THE MARYLAND-NATIONAL CAPITAL PARK AND PLANNING COMMISSION

**MEMORANDUM**

**REVIEW TYPE:** Mandatory Referral  
**PROJECT NAME:** Takoma Park Community Center  
**APPLICANT:** City of Takoma Park  
**CASE NUMBER:** 02101-TP-1  
**REVIEW BASIS:** Article 28, Chapter 7-112 of the Regional District Act  
**ZONE:** R-60  
**MASTER PLAN:** Takoma Park Master Plan  
**FILING DATE:** June 5, 2002

Site Plan with Comments

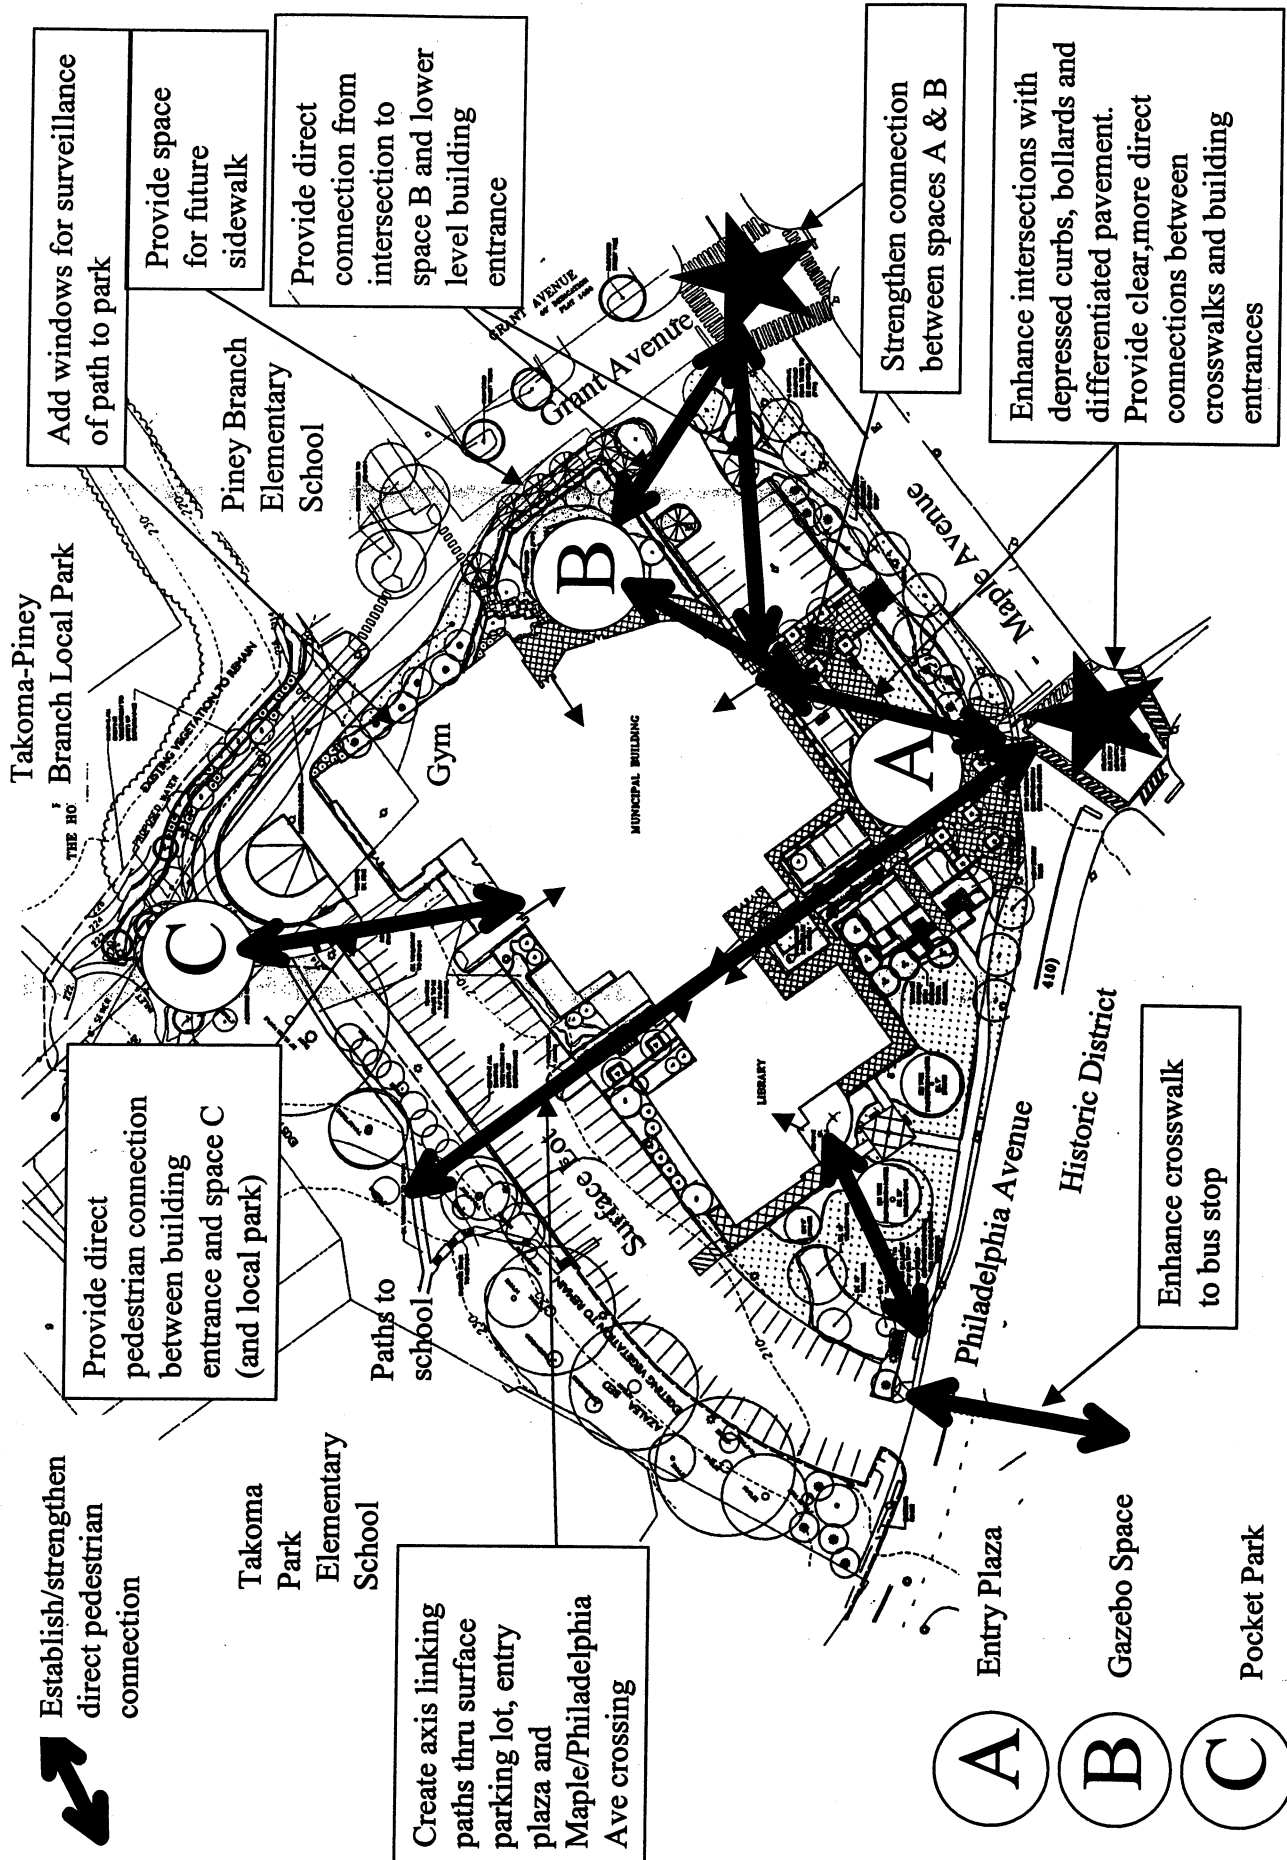
8. Ensure a sufficient radius for emergency vehicles in cul de sac

4. Address compatibility concerns of neighbors

1.c. Revise parking lot design for better pedestrian and bike access and landscaping

3. Provide 25 foot setback & screen the parking lot

2. Provide for class 1 bike path to Piney Branch Road with connections to building

6. Design and build west side of Grant so a sidewalk can be added in the future

3. Screen the parking facility

1.b. Add streetscape features

2. Provide for class 2 or 3 bikeway route & connect to building

5. Work with SHA to address safety improvements

1.a. Reduce radius of curb and shorten crossing distance
